**Lot 17 Woodbridge South**  
**41 Avents Way**  
**Fuquay Varina, NC 27540**

**PLAN 1**  
**The Clayton - LH**

**PLAN 1 - THE CLAYTON - LH**

**'LOW COUNTRY' BASE FIRST FLOOR PLAN**  
SCALE: 1/8"=1'-0" ON 11x17, 1/4"=1'-0" ON 22x34  
NO 2nd FLOOR

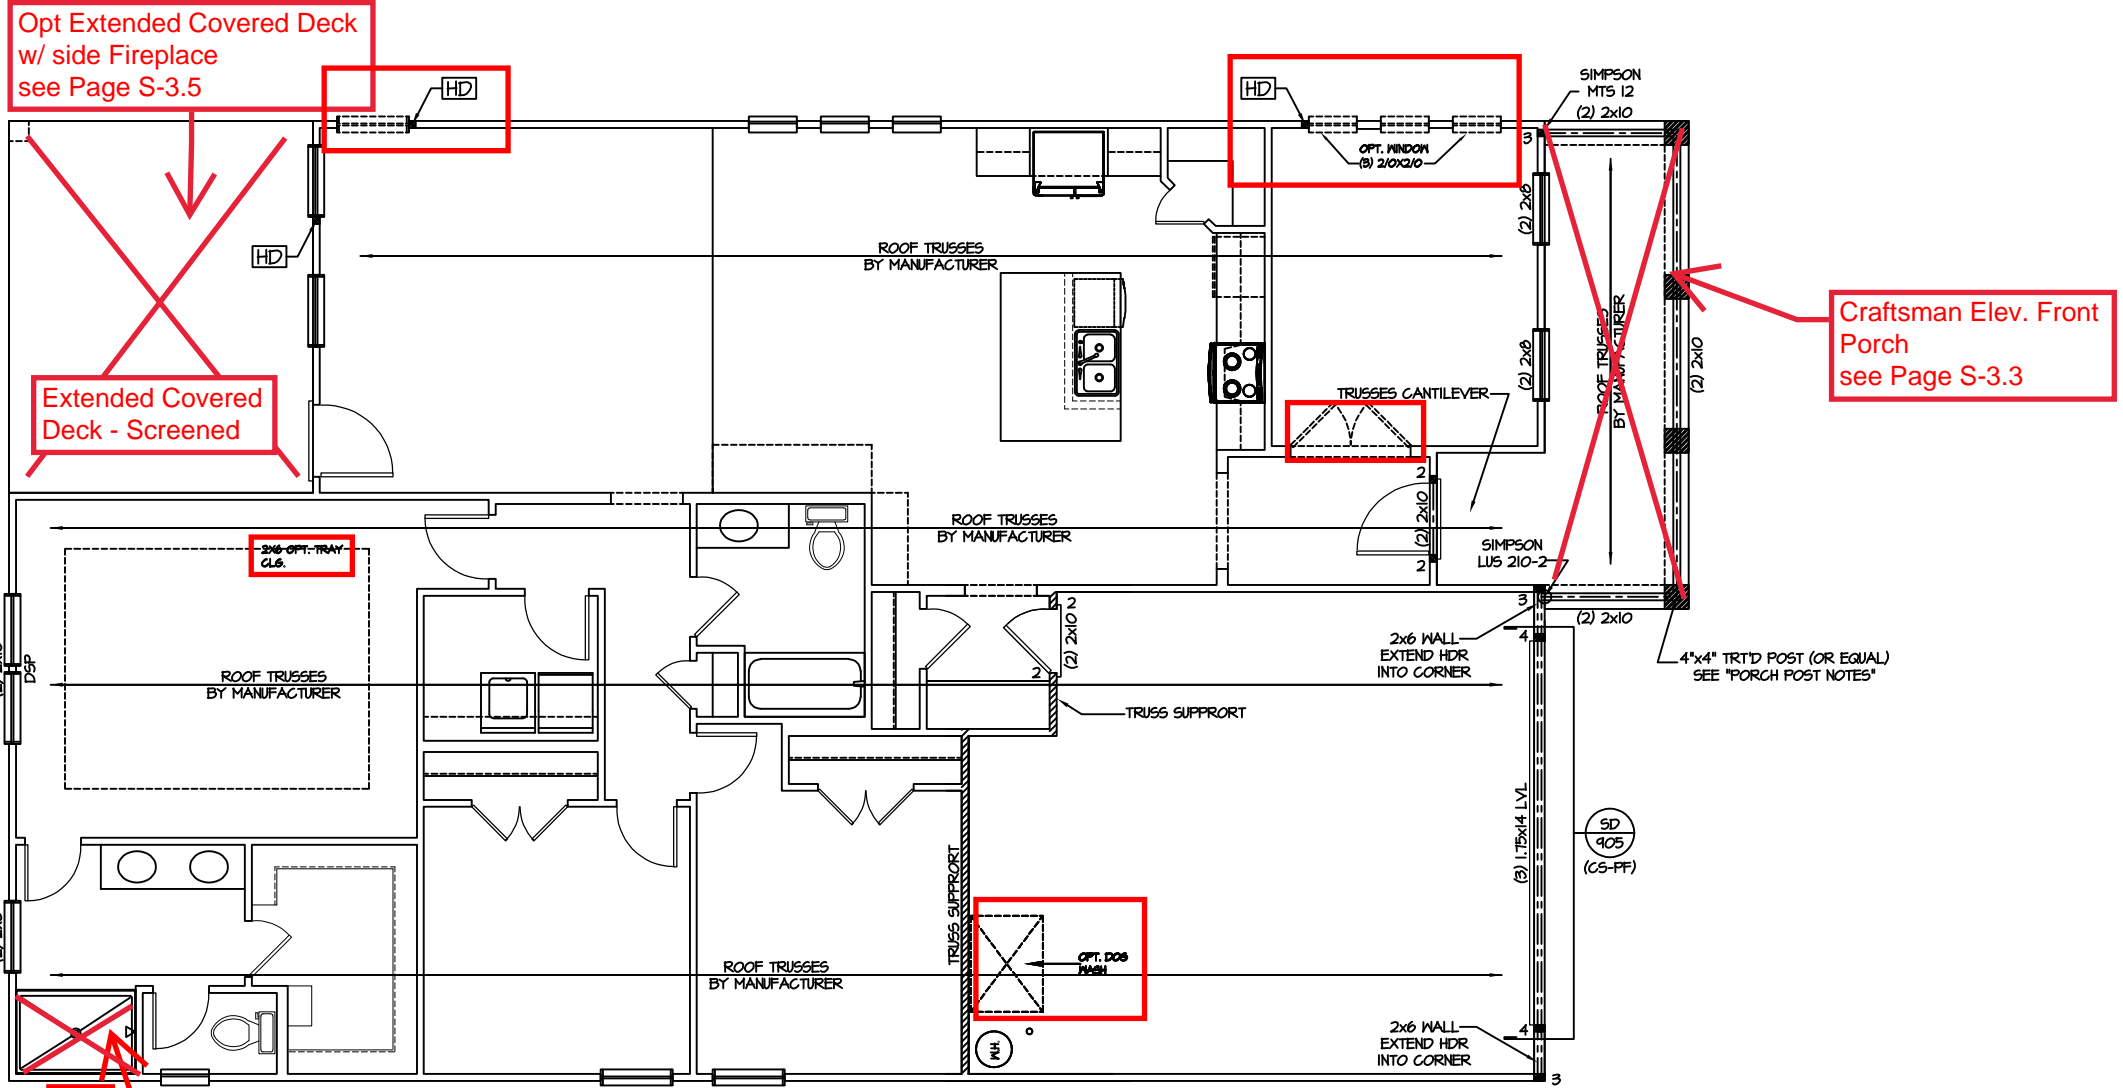
Add 4/0 x 1/0 Tansom @ Shower

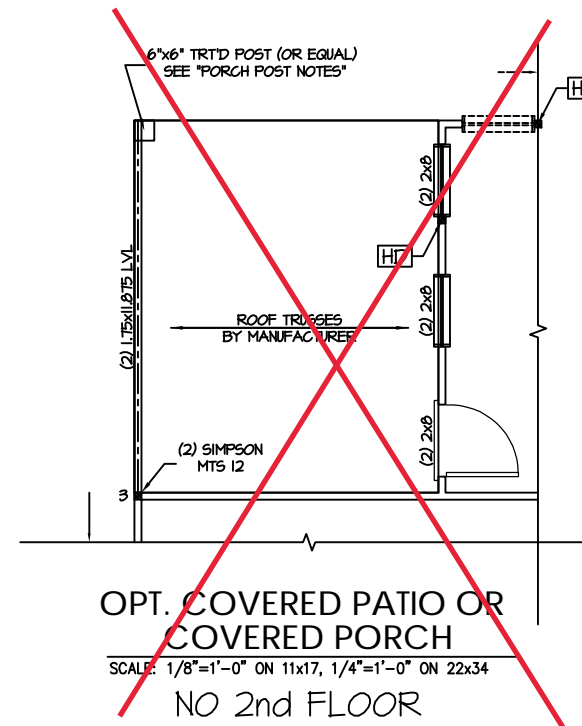
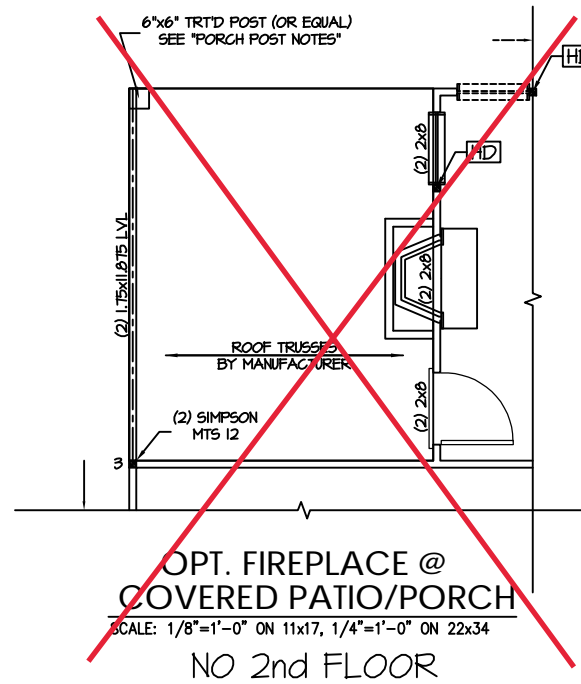
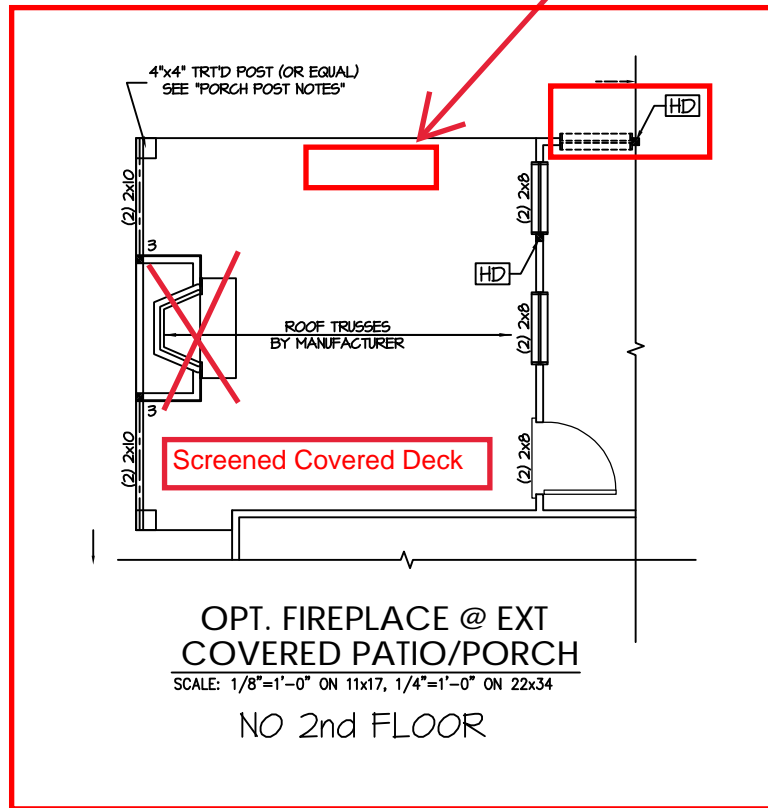
move Fireplace to side wrapped in Stone

**'CRAFTSMAN' ROOF FRAMING PLAN**

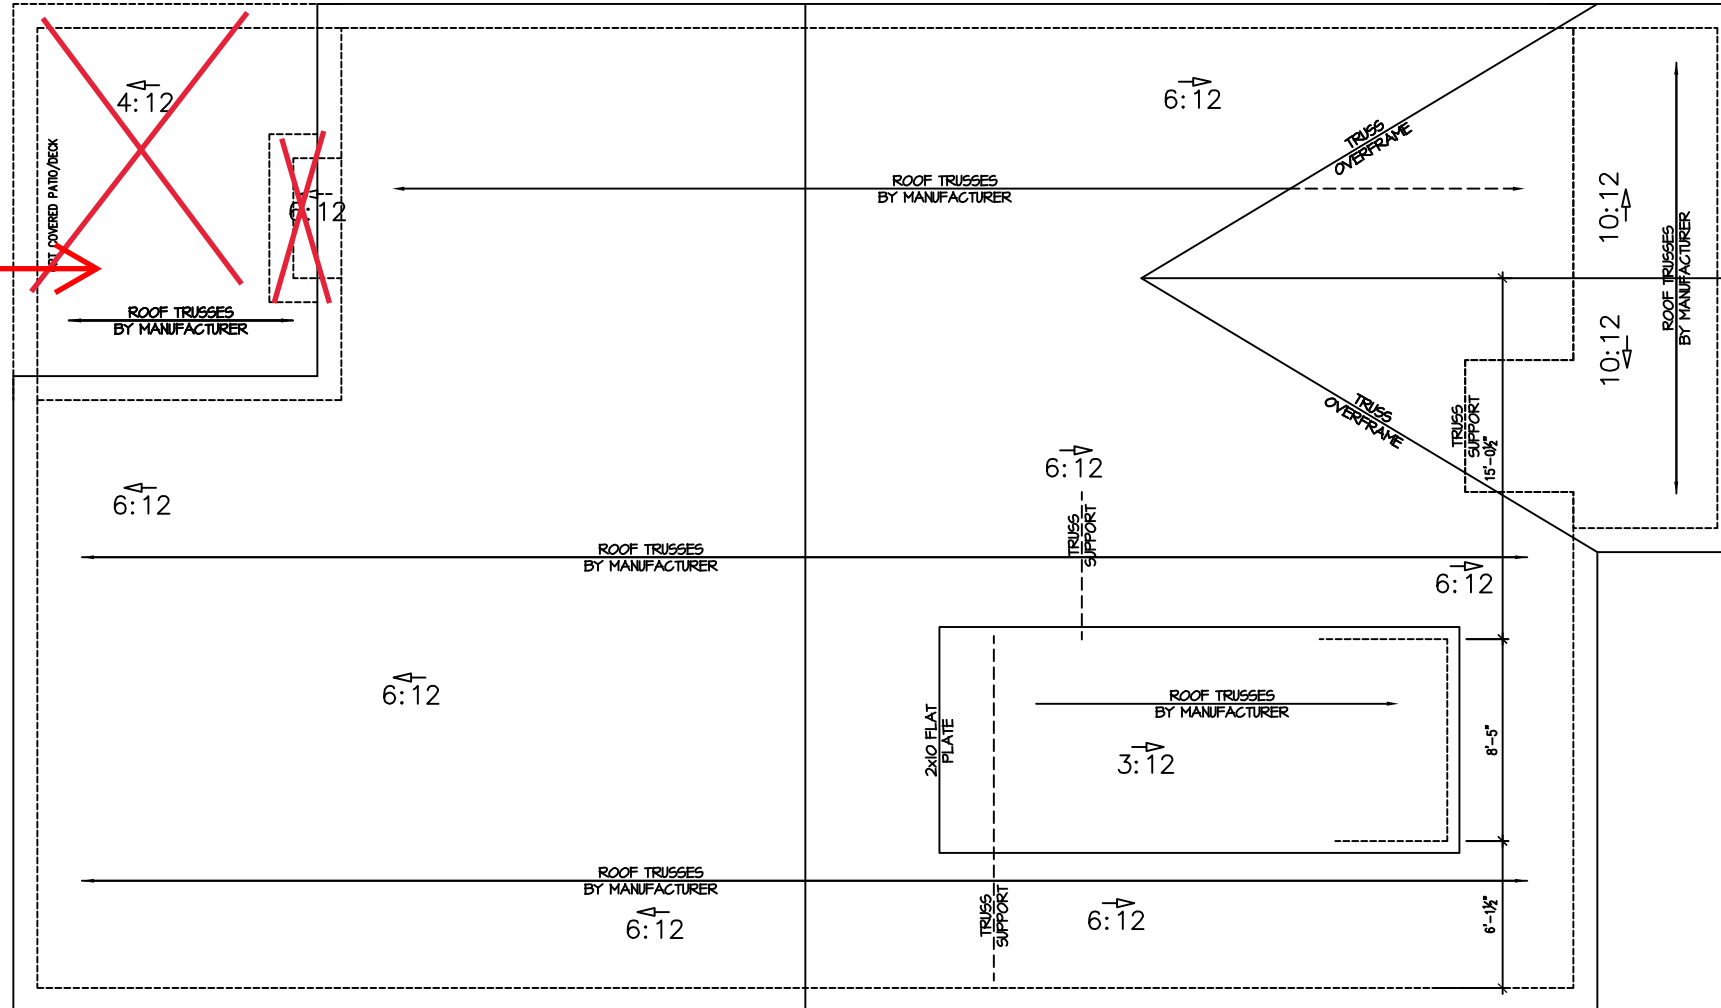
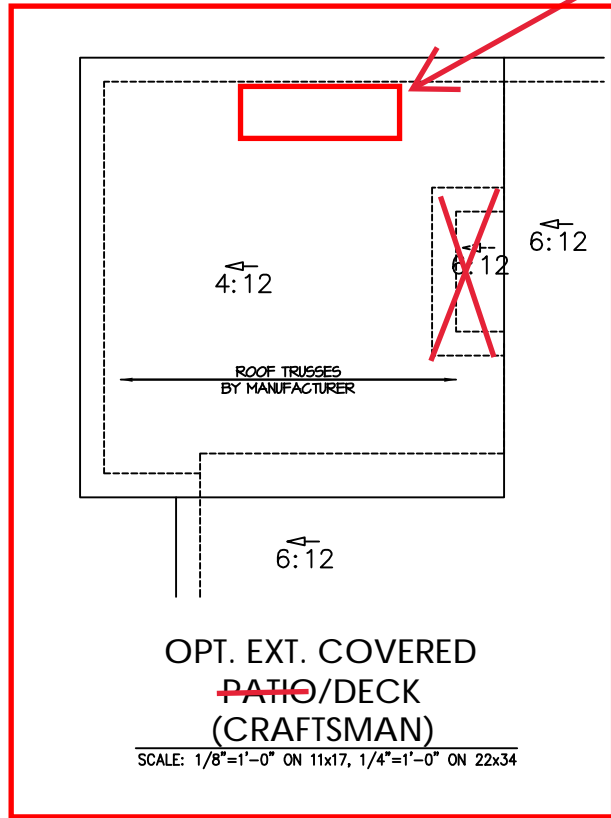
Fireplace moved to Side wrapped in Stone
